On Wed, Dec 9, 2015 at 1:32 PM, Mier, Jena <[Jena.Mier@nexteraenergy.com](mailto:Jena.Mier@nexteraenergy.com)> wrote:

**The following summarizes the commitments from the September 16, 2015 meeting:**

FPL TURKEY POINT UNITS 6 & 7 SITE CERTIFICATION APPLICATION  
PLANT AND NON-TRANSMISSION FACILITIES  
4<sup>TH</sup> ROUND COMPLETENESS

**Location of the West Consensus and West Preferred Corridors Relative to Wood  
Stork Colonies**

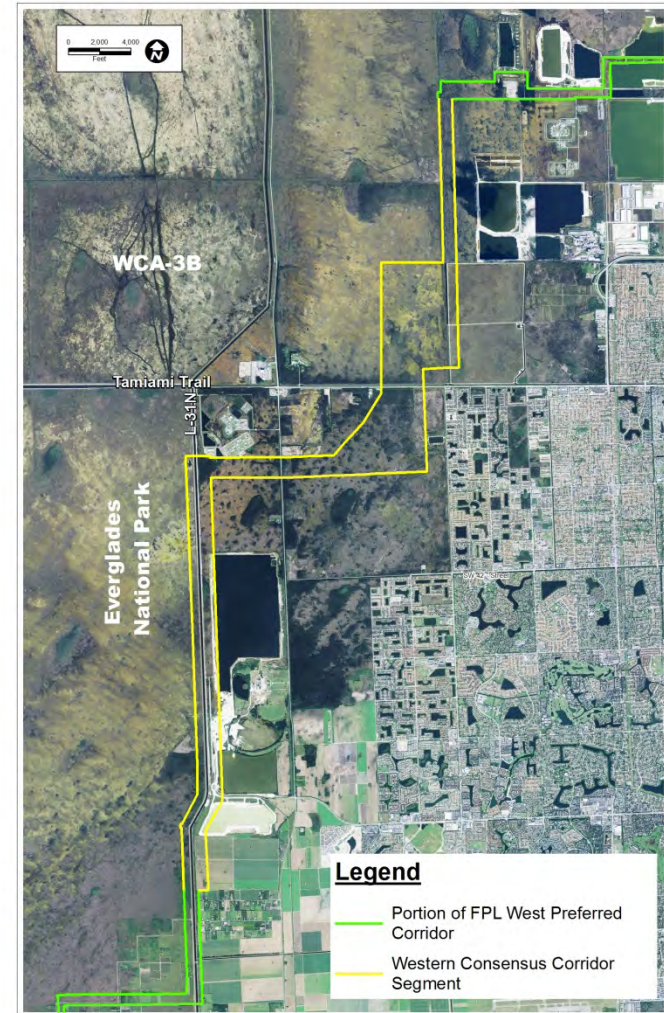
8. Attached are figures illustrating the location of the West Consensus and West Preferred Corridors and their proximity relative to wood stork colonies (see Attachment 3).

- Certified Corridors avoid all known wood stork colonies
- Four colonies exist in corridor vicinity: Tamiami East 1 and 2, Tamiami West, and 3B Mud East
- Certified Corridors cross portions of nine core foraging areas (CFAs); USFWS foraging habitat analysis based on worst-case wetland impacts will be revised upon final transmission line design

**Figure 3 – 3: Conceptual Spoils Storage Area Design**

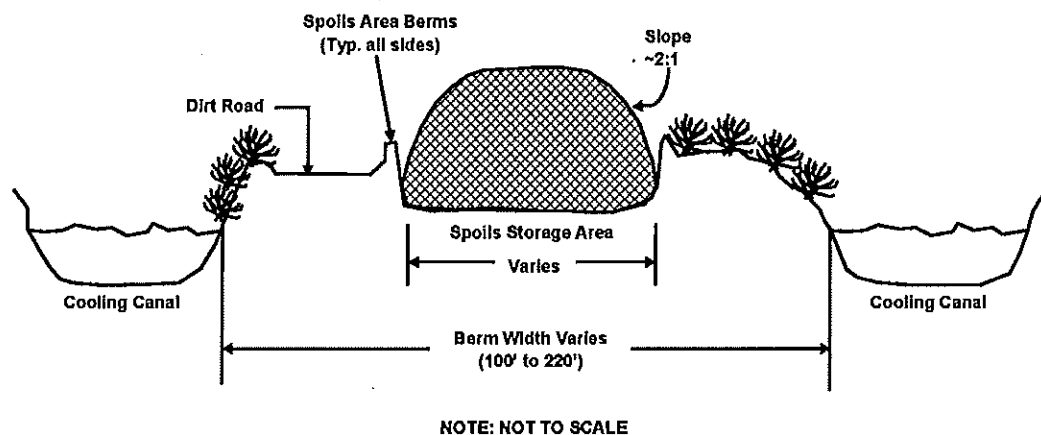
9. FPL's Avian Protection Plan is included as Appendix A of the Biological Assessment.
10. Attached is the Conceptual Earthwork and Materials Disposal Plan, illustrating the conceptual design for muck storage that prevents discharge of material to the cooling canal system (see Attachment 4).

During the preparation of the spoils storage area, the center of the area will be excavated to construct berms around the spoils storage area. The berm will be constructed with a height and slope sufficient to provide erosion control to prevent spoils and sediment runoff from entering the cooling canal system. The conceptual spoils storage area design is shown in Figure 3 – 3. The estimated height of the spoils pile will be determined after the spoils storage area has been surveyed and a final dirt road width for the berms has been established. It is anticipated that the final spoils elevation will be approximately 16 ft – 20 ft NAVD88.
